RE: DEVELOPMENT APPLICATION DA 2020/0816
23-33 BASSETT STREET MONA VALE

**DEVELOPMENT APPLICATION DA 2020/0816
23-33 BASSETT STREET MONA VALE
PROPOSED RESIDENTIAL CARE FACILITY UNDER SEPP HOUSING
FOR SENIORS**

Figure 1- North elevation showing west boundary of site and relationship with adjoining cottage style development

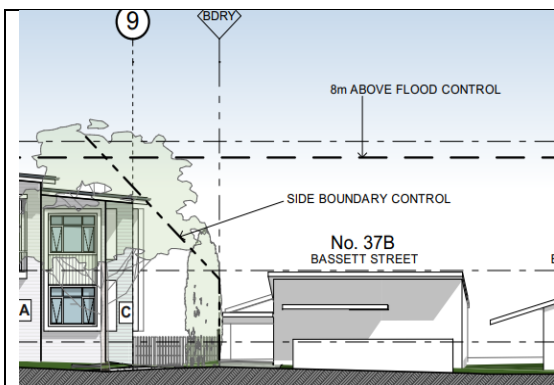
This site is not in a medium density residential zone nor is the property located in a mixed use commercial type environment. The fact that the site is zoned for 'low density residential' purposes should be instructive to the applicant as far as the development proposal is concerned. This is especially the case where low density residential extant development is to be replaced by a high density facility (over the eastern part of the land). We contend that the architect has failed to take into account the reasonable expectations of adjoining land owners and occupiers in this regard. Figures 1 and 2 below show the relationship between the proposal and adjoining development to the east and west (source Gartner Trovato Architects). In our opinion the separation between the built elements in Figure 1 is not acceptable.

Figure 2- North elevation showing east boundary of site and relationship with adjoining cottage style development

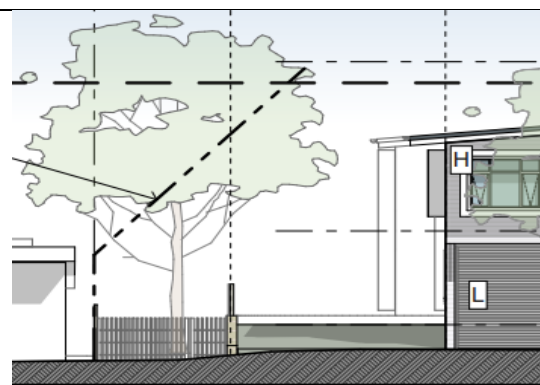
We note that the proposed floor space ratio (FSR), which is set at 0.95:1 means that in this case, given the restricted height, a very squat disproportionately lengthy built form of around 95m will result. Further however, the building is excessively bulky and is not satisfactorily relieved and articulated when viewed from the street frontage and both the east and western boundaries. From the south, the significant setback means that the bulk and scale will be a far less critical issue, in terms of the public domain or amenity.

In our view the building should be broken into at least two built elements crossways, so that some respect can be paid to the built form of existing cottages in other parts of this streetscape (with their narrow frontages), the relevant low density zone and the PDCP character statement suggesting that vegetation should be integrated with development. In this case the reduced street setbacks will not allow for sufficient planting to soften this bulky and very lengthy facade.
